**CITY OF ONTARIO
DEVELOPMENT ADVISORY BOARD**

AGENDA

June 5, 2017

- B. ENVIRONMENTAL ASSESSMENT AND DEVELOPMENT PLAN REVIEW FOR FILE NO. PDEV16-020:** A revision to a previously approved Development Plan (File No. PDEV16-020), to add 49,912 square feet of warehouse area to an existing 426,406-square foot furniture store and warehouse (Mathis Brothers), for a total building area of 476,318 square feet on approximately 19.23 acres of land located at 4105 East Inland Empire Boulevard, within the Garden Commercial land use district of the Ontario Center Specific Plan. The environmental impacts of this project were previously reviewed in conjunction with Environmental Impact Report No. 88-2, certified by the Ontario City Council on March 19, 1991. This application introduces no new significant environmental impacts. The proposed project is located within the Airport Influence Area of Ontario International Airport (ONT), and was evaluated and found to be consistent with the policies and criteria of the Airport Land Use Compatibility Plan (ALUCP) for ONT (APN: 0210-205-12); **submitted by Mathis Properties California, LLC.**

Exhibit B: Proposed Site Plan

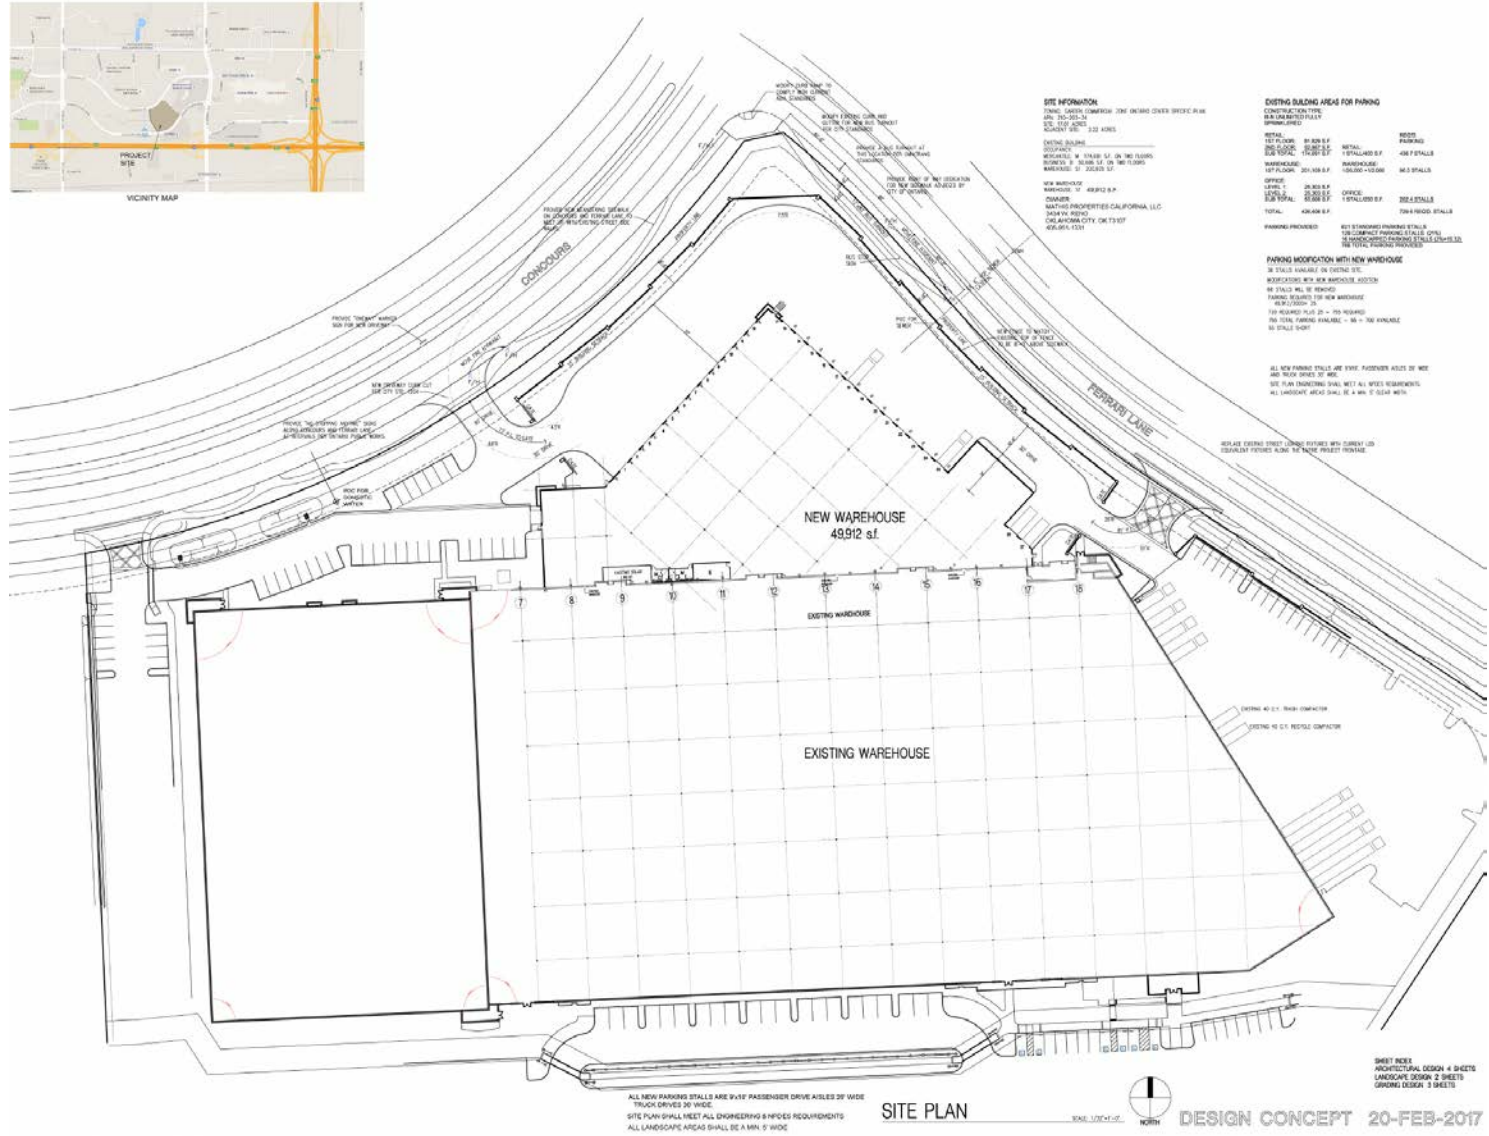
(f) At the "Sleep Center," provide a minimum 4-foot wide continuous landscaped planter, which extends the full length of the easterly and westerly (side) building elevations. Said planter shall wrap to the front of the building, terminating at the building entry popout.

(g) The landscaped planter located at the southwesterly corner of the "Sleep Center" pad shall be substantially increased in area, increasing the width by a minimum of 5 feet.

Exhibit C: Elevations

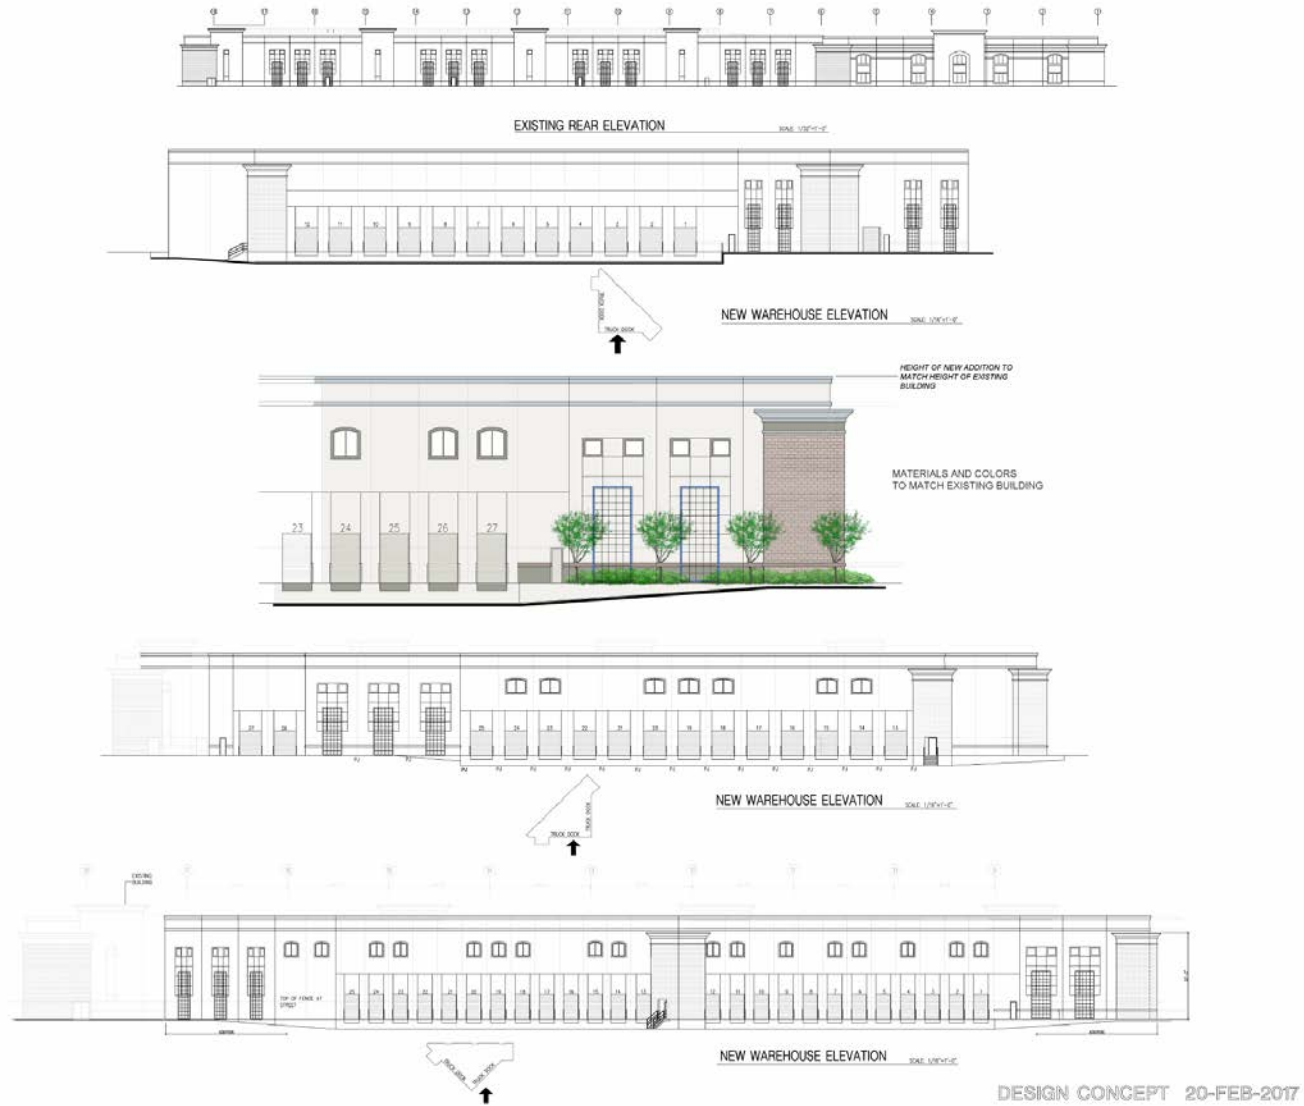
2.12 Architectural Treatment. The exterior elevations of the Sleep Center Building shall be revised as follows:

(a) The entry element on the front of the Sleep Center Building shall be fully walled and finished on four sides, and shall include details appropriate to the building (i.e., decorative cornice treatment), so as to be a fully three-dimensional, four-sided element of the building, to the satisfaction of the Planning Director.

(b) Glazing shall be provided at the top corners of the grid reveals shown on the side and rear exterior elevations of the Sleep Center Building (identified as “recesses” on the plans), consistent with the architectural elements of the existing main building (Note: Spandrel glass may be used).

Exhibit D: Landscape Plan

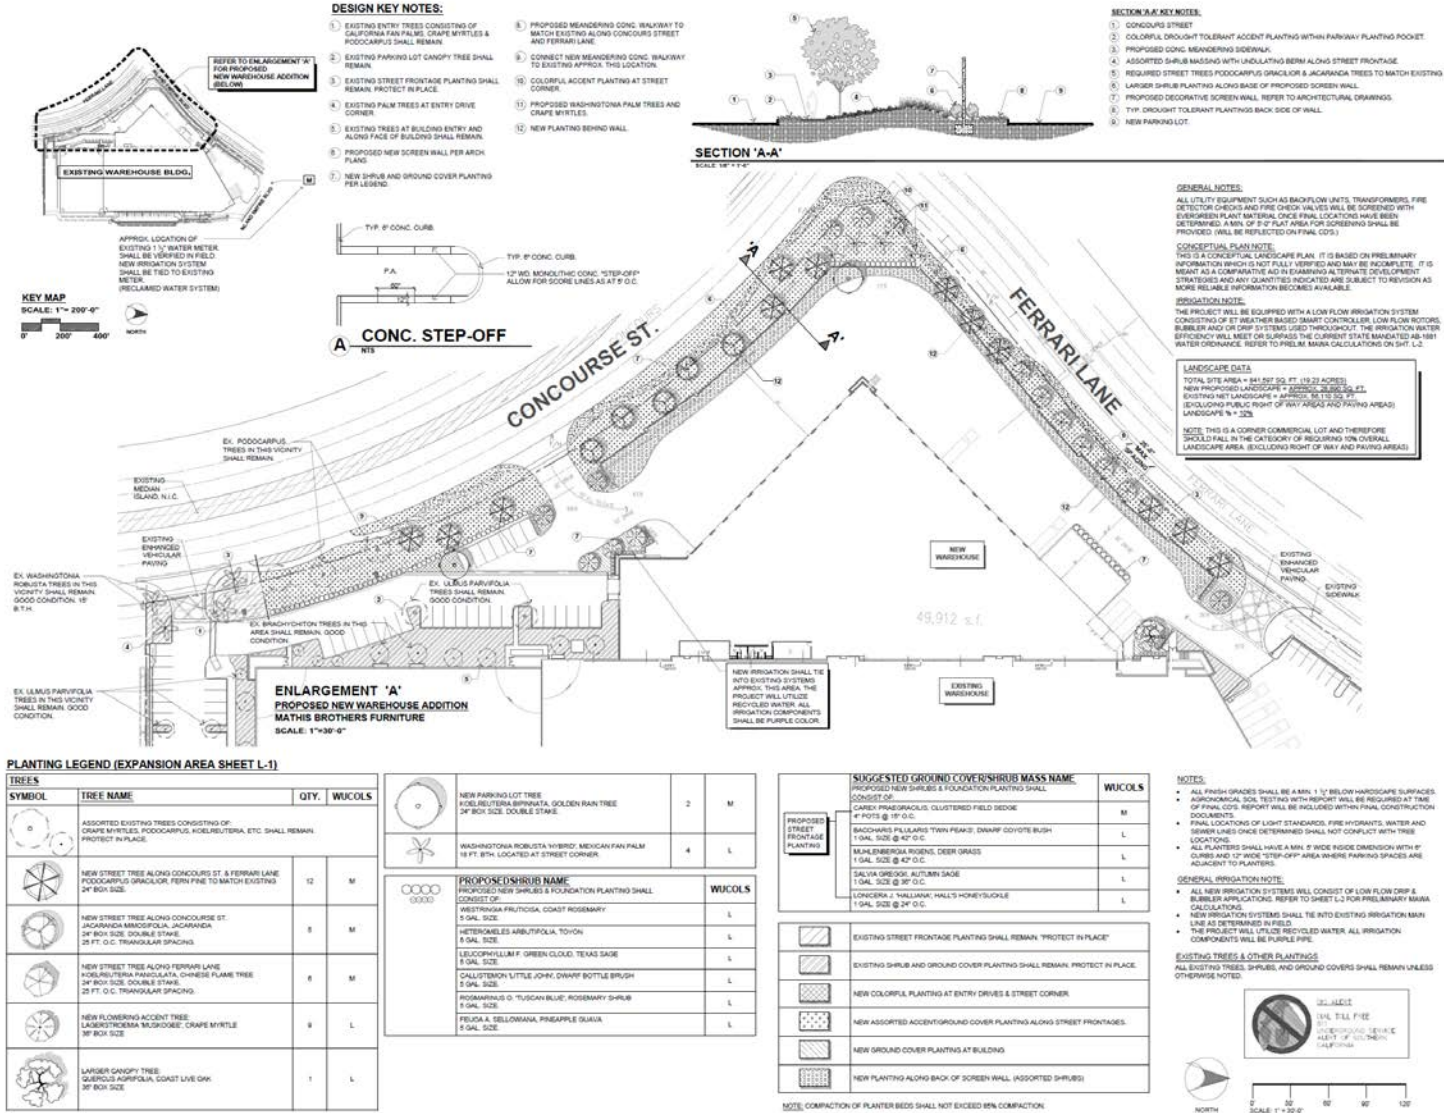
- Adjust street tree layout to match the Ontario Center Specific plan. See page 41 and exhibit 4-2 Show dense tree and shrub planting in a curvilinear layout on Concours. Balance and match trees on both sides of driveways on Concours and Ferrari. Add trees to be min 30' oc. where greater.
- Show 25% California native trees. (Platanus racemosa, Quercus agrifolia, Quercus wislizenii, Quercus douglasii, Cercis occidentalis, Sambucus Mexicana, etc.). Use large trees in larger locations, including interior yard corner planters that are greater than 10' wide.
- Add narrow trees and tall shrubs to soften screen walls.
- Consider low water turf substitute for the parkways such as Kurapia, Lonicera, etc.

- Provide a tree inventory for existing trees include genus, species, canopy width and condition. Show and identify trees proposed to be removed. Add tree protection notes on construction and demo plans.
- Note for agronomical soil testing and include report on landscape construction plans.
- Civil plans shall dimension all planters to have a minimum 5' wide inside dimension with 6" curbs and 12" wide curbs where parking spaces are adjacent to planters.

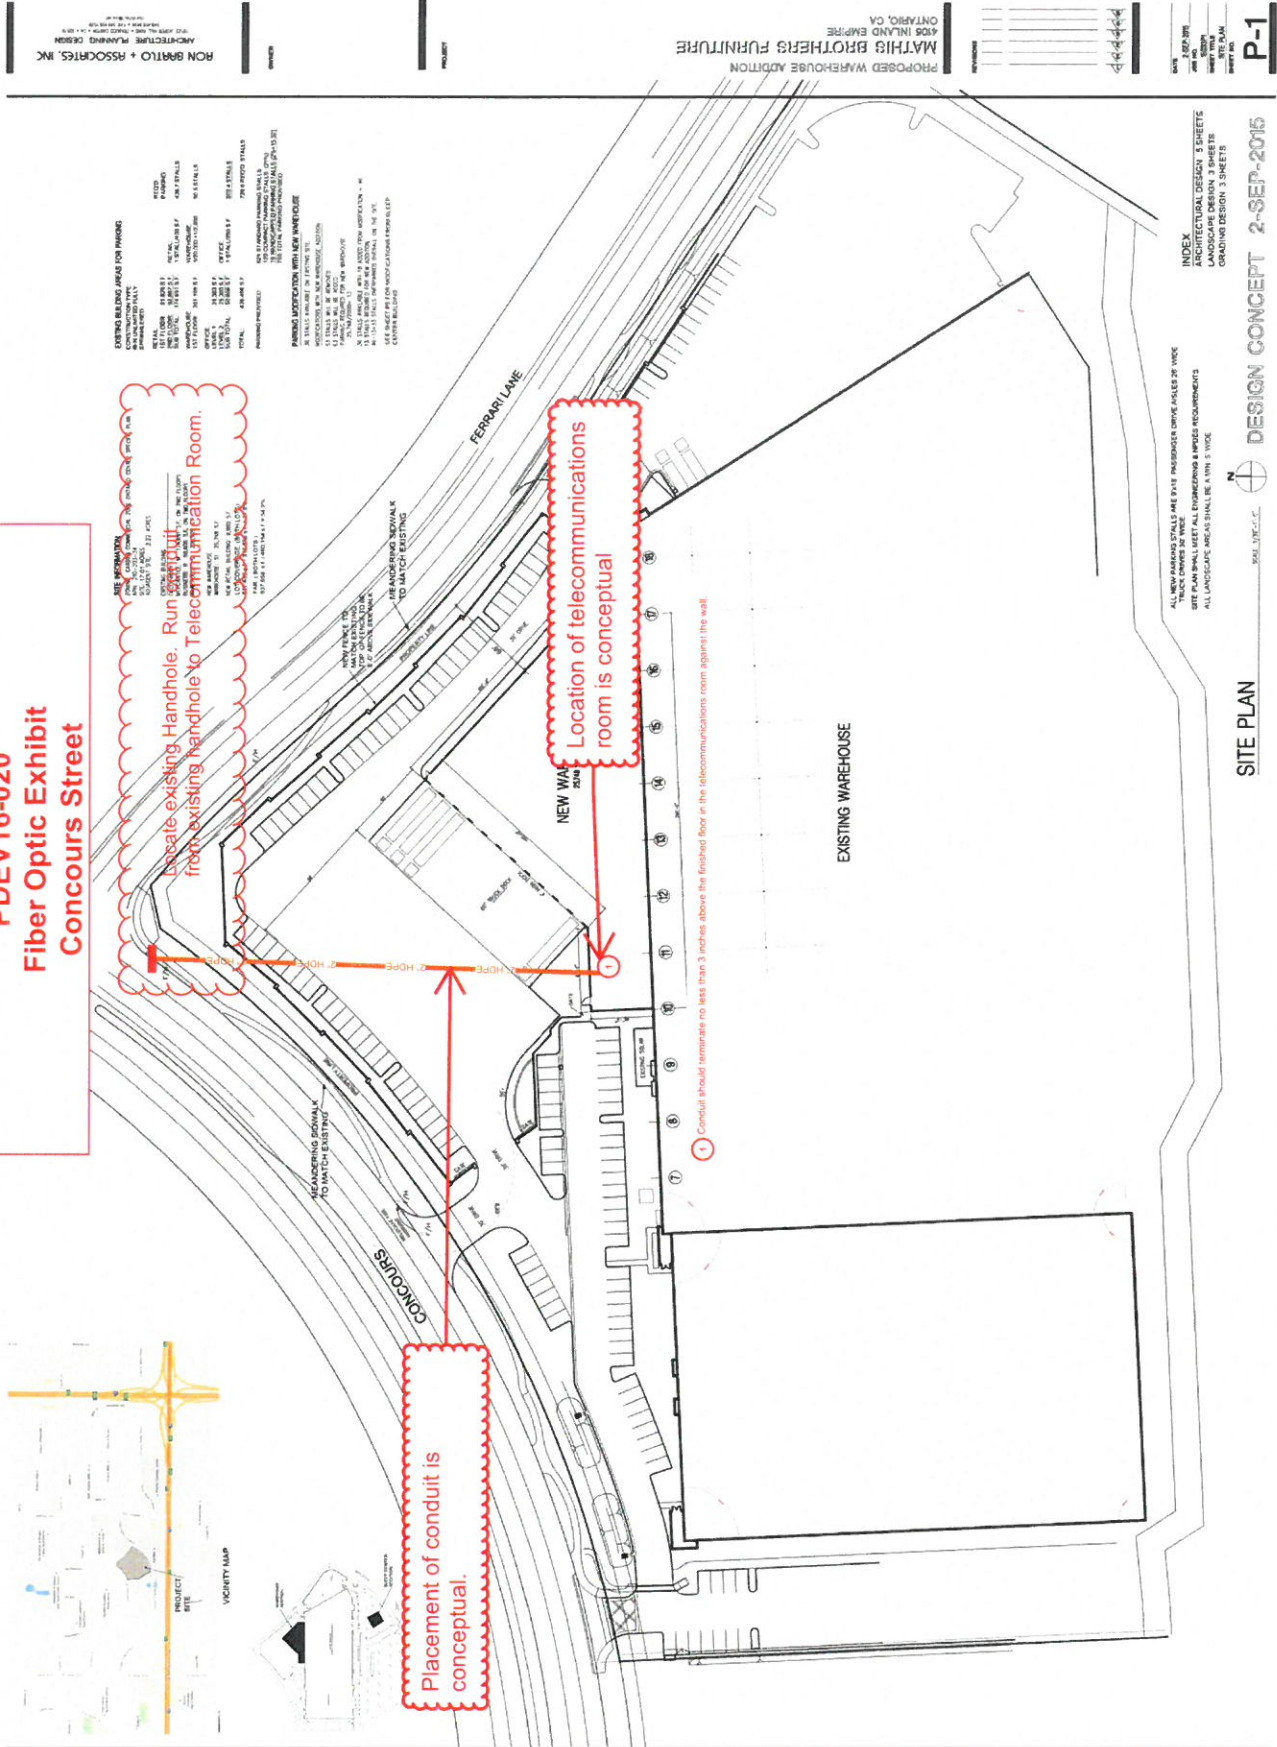
Placement of conduit is conceptual.

Location of telecommunications room is conceptual

Conduit should terminate no less than 3 inches above the finished floor in the telecommunications room against the wall.
